SMC RED to BLACK Conversion Assembly
ONE Disc Clutch (Part #4251)

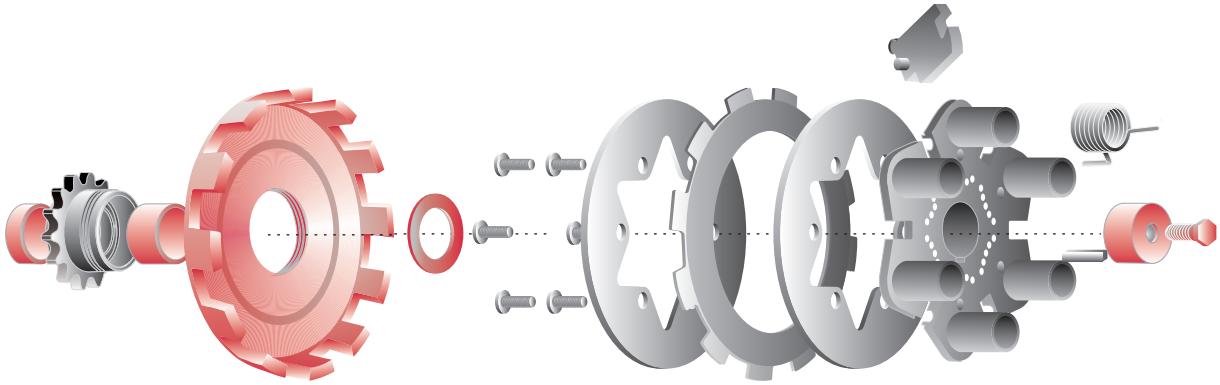
Caution:
Vortex BLACK drive hubs are 0.050 inch shorter than the new Vortex RED drive hubs. Install the 0.050 thick washer P/N 4211 immediately before installing the drive hub when using the new ball bearing sprockets.
